Reference: Division of Facilities Construction and Management
New North Ogden Liquor Store and Demolition And Replacement Of The
Ogden (Patterson Avenue) Liquor Store
DFCM Project Nos. 04242030 and 04180030

Subject: **Addendum No. 4**

Addendum No. A04

**New Harrisville, Ut Liquor Store
Department of Alcoholic Beverage Control
433 North Main Street, Tooele, Utah
DFCM Project No. 04242030**

AS
103

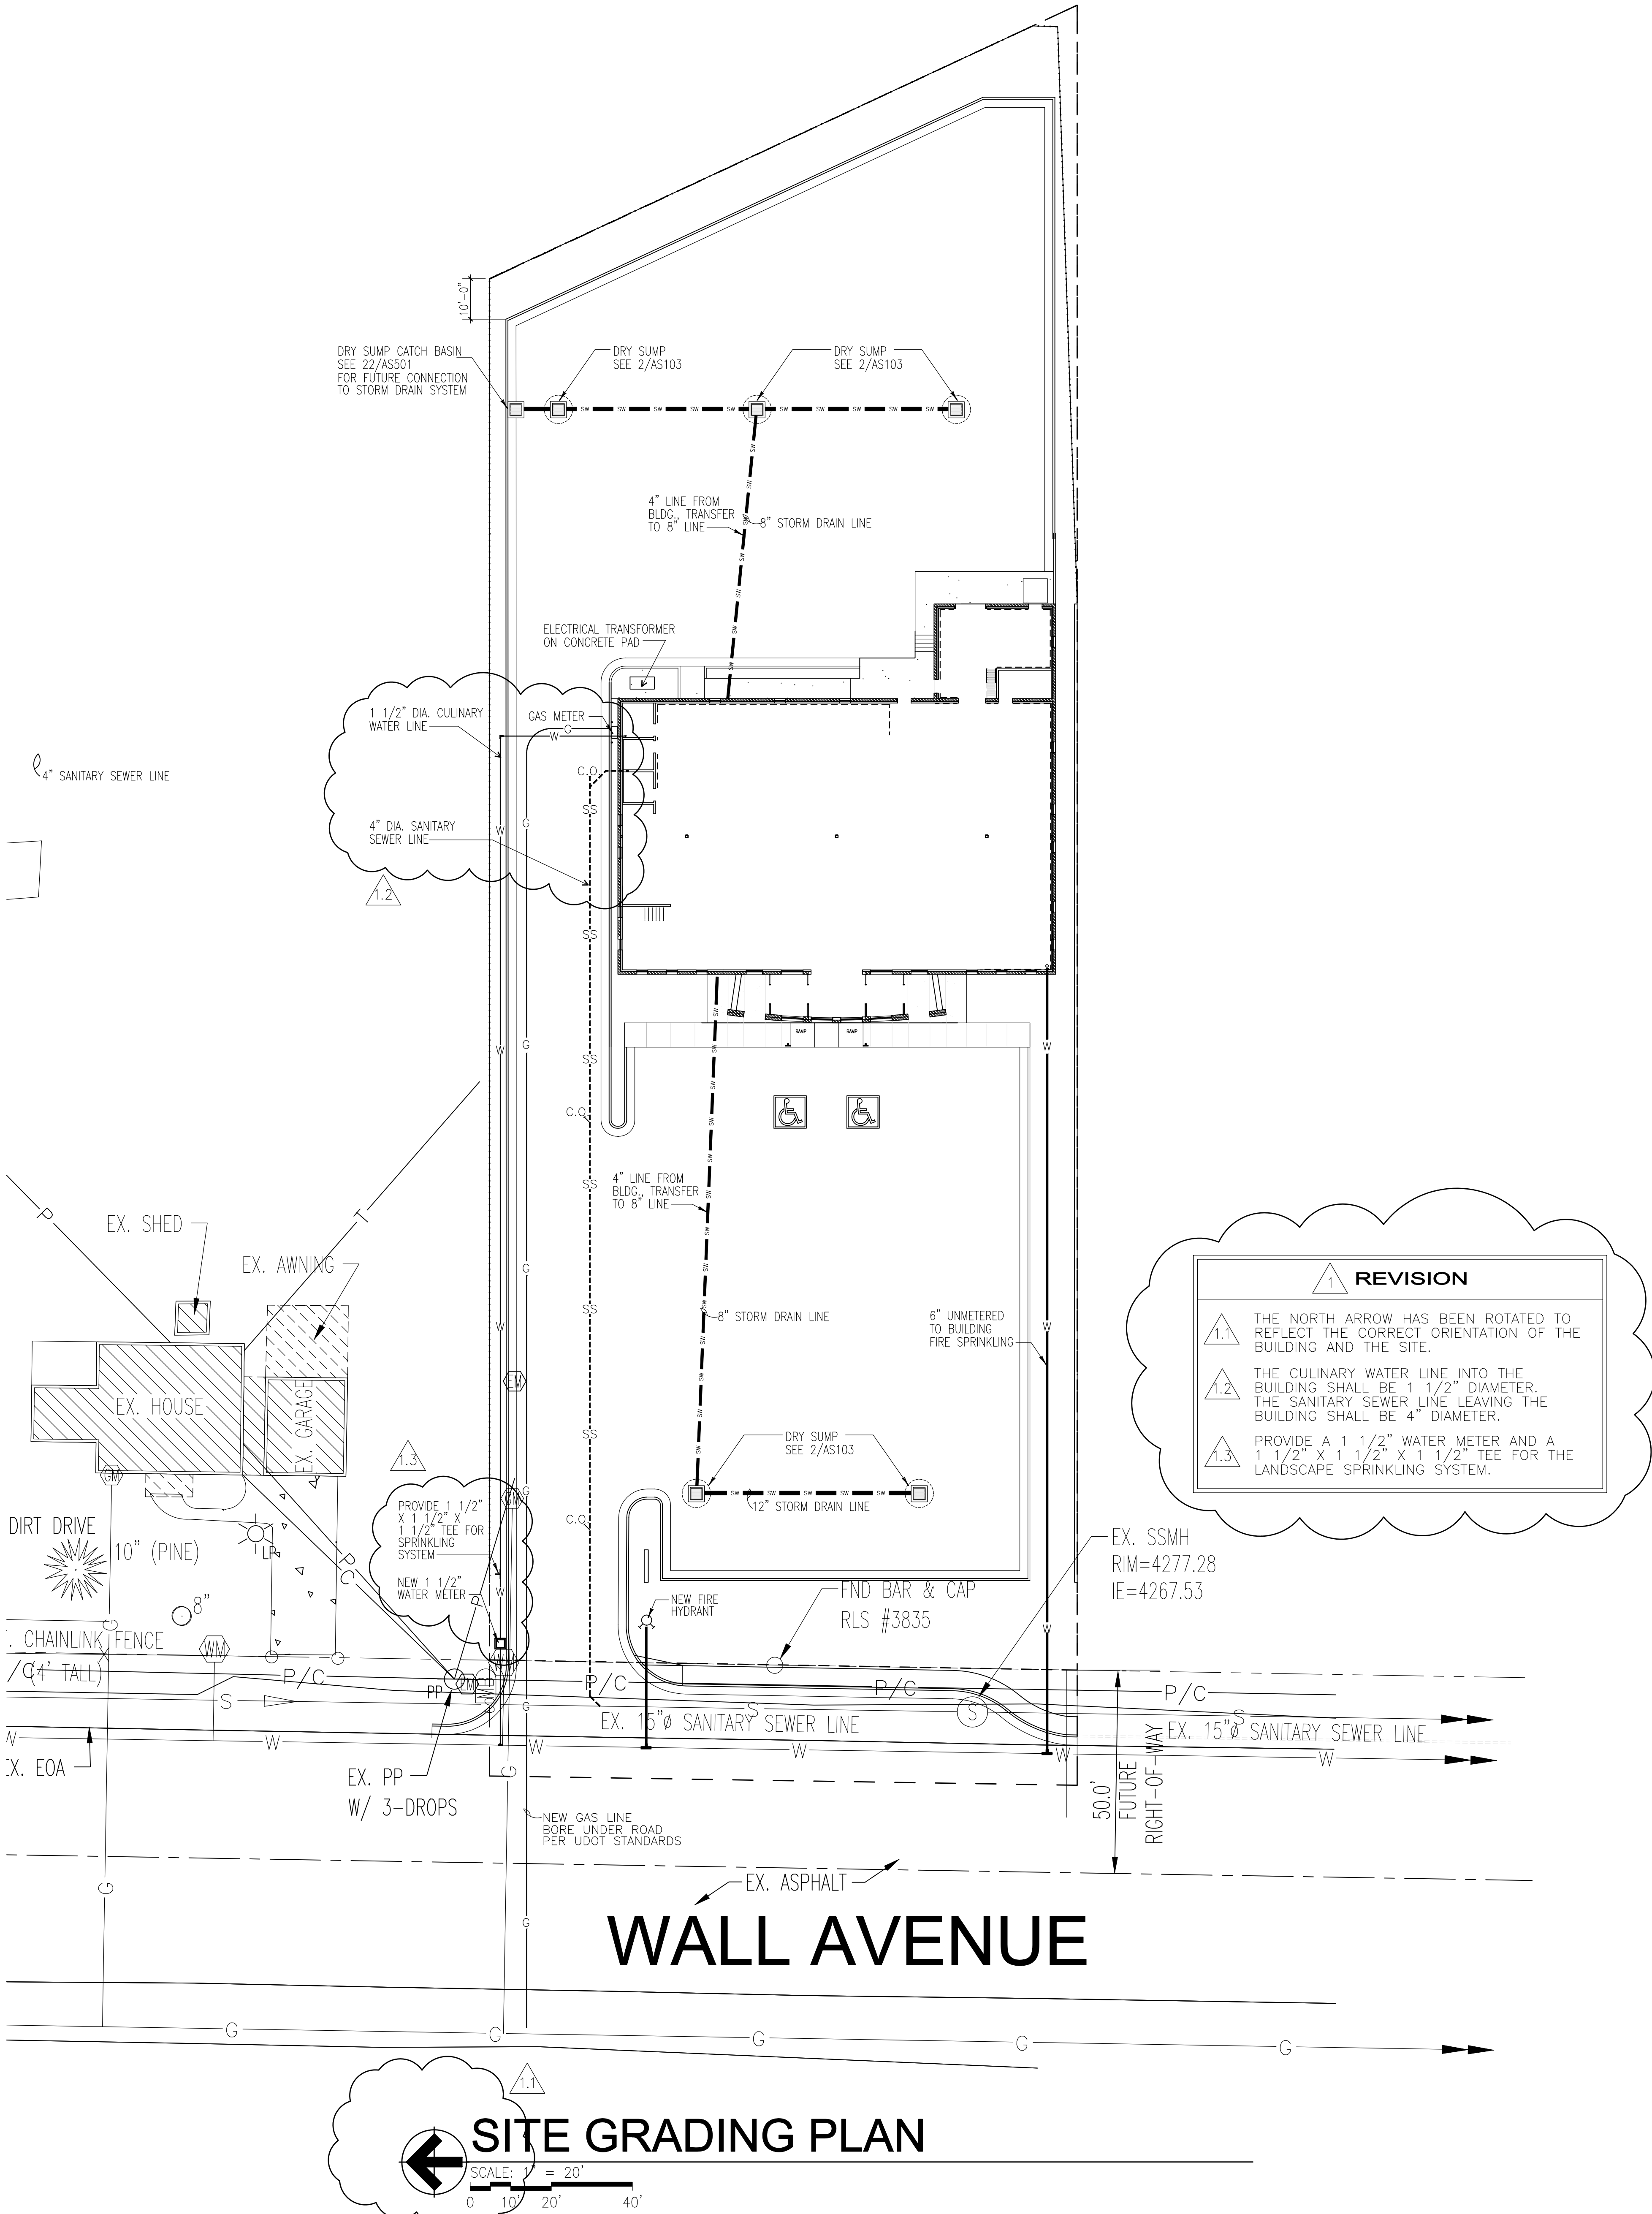
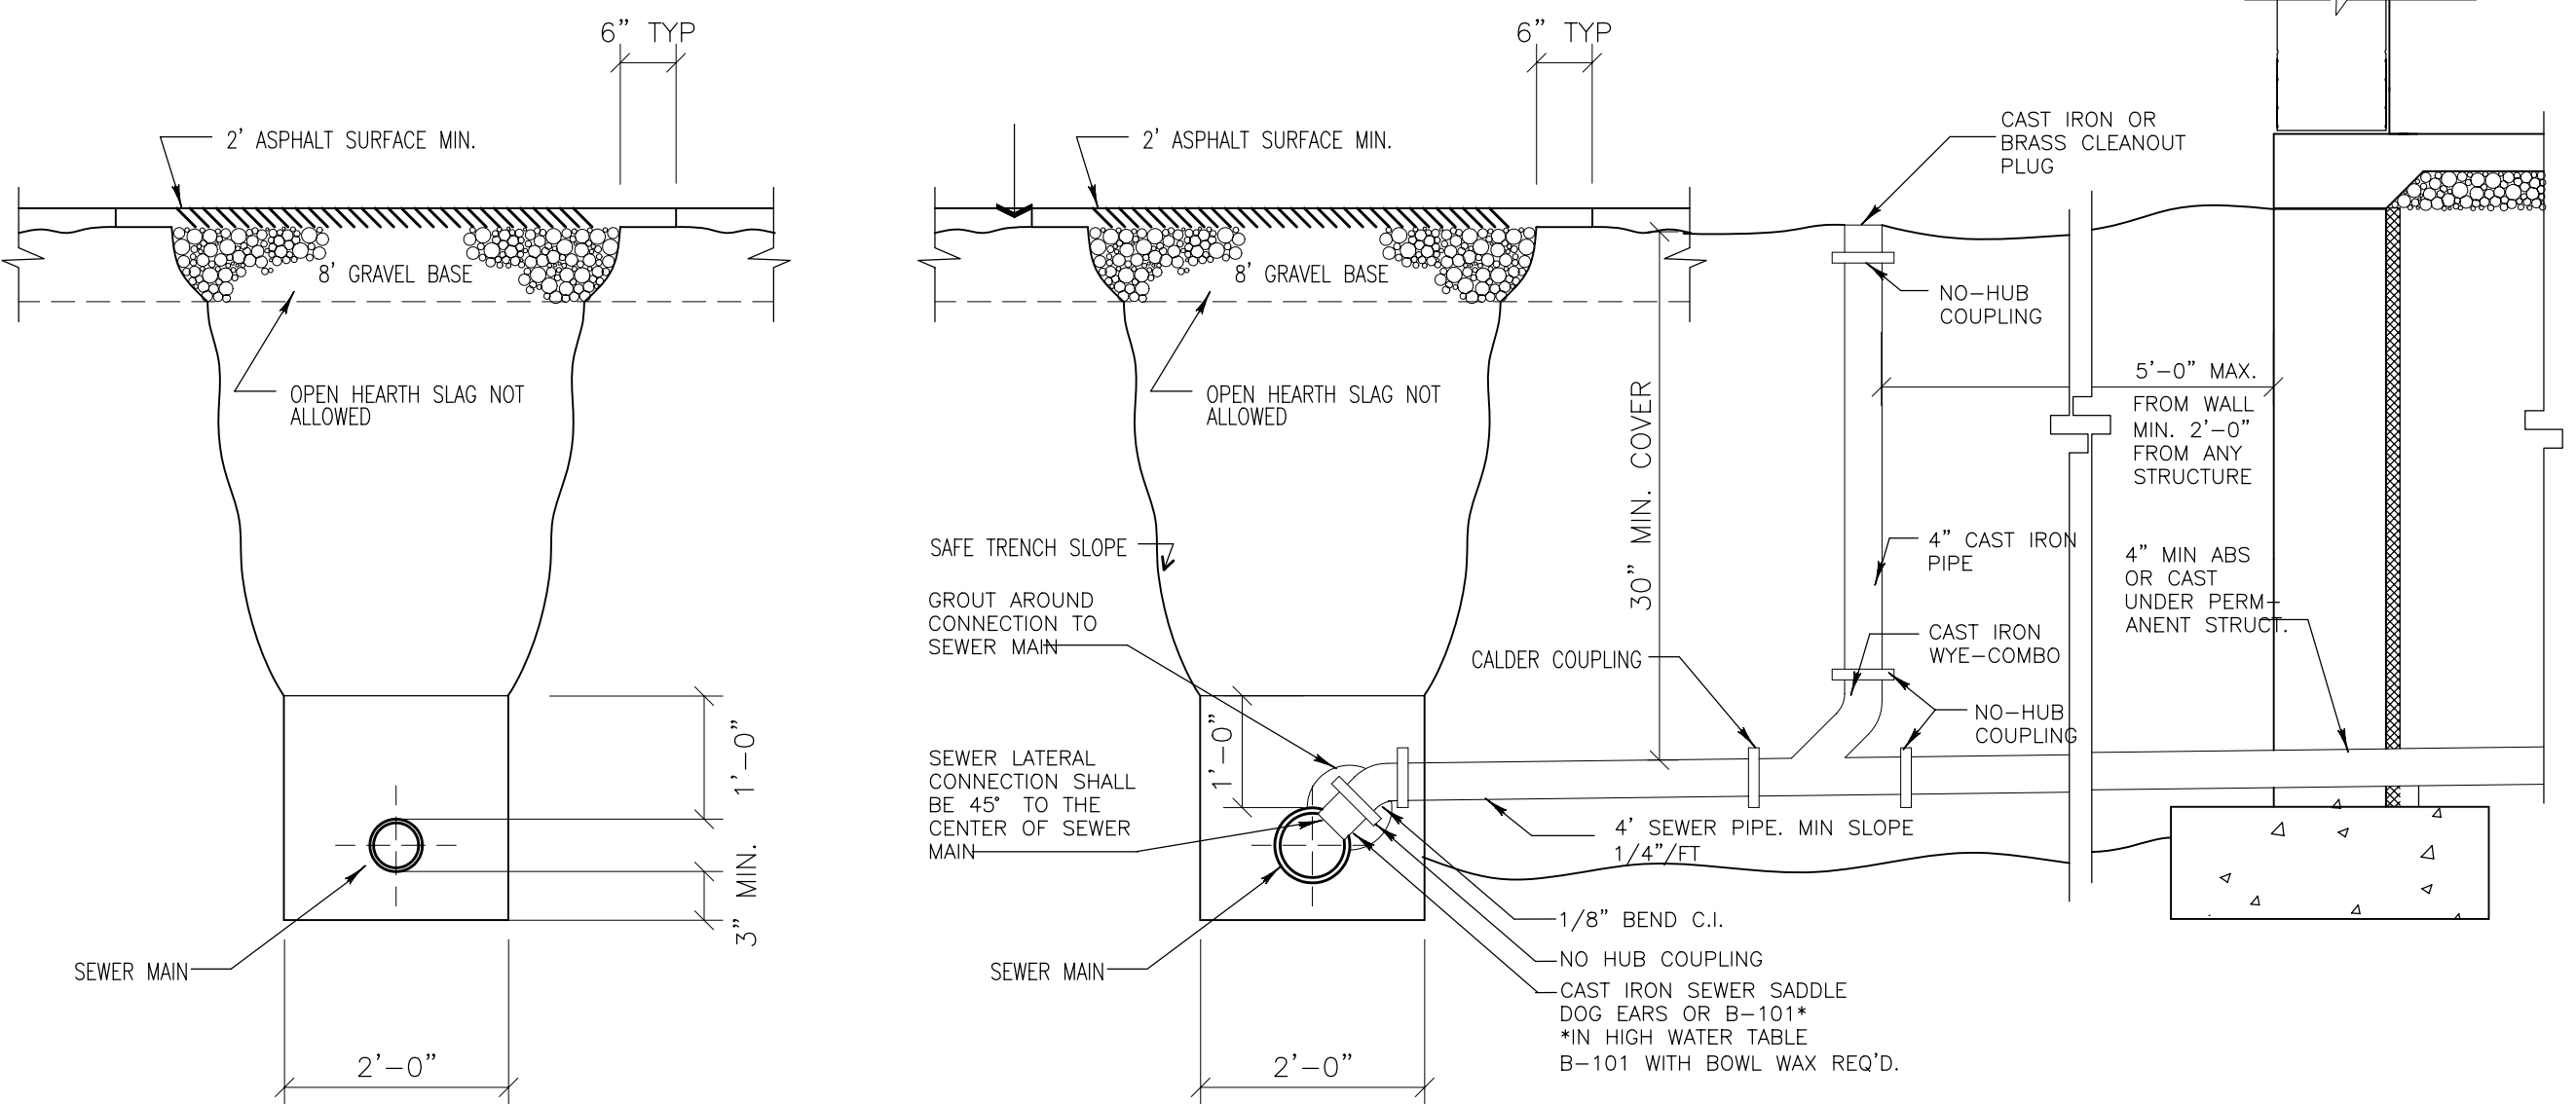
Drawing AS103 has been re-issued with the following changes:

- 1.1 The north arrow has been rotated and clouded to reflect the correct orientation of the building and the site.
- 1.2 The culinary water line into the building shall be 1 1/2" diameter. The sanitary sewer line leaving the building shall be 4" diameter. Notes to this effect have been added and clouded.
- 1.3 Provide a 1 1/2" water meter and a 1 1/2" x 1 1/2" x 1 1/2" tee for the landscape sprinkling system. Notes to this effect have been added and clouded.
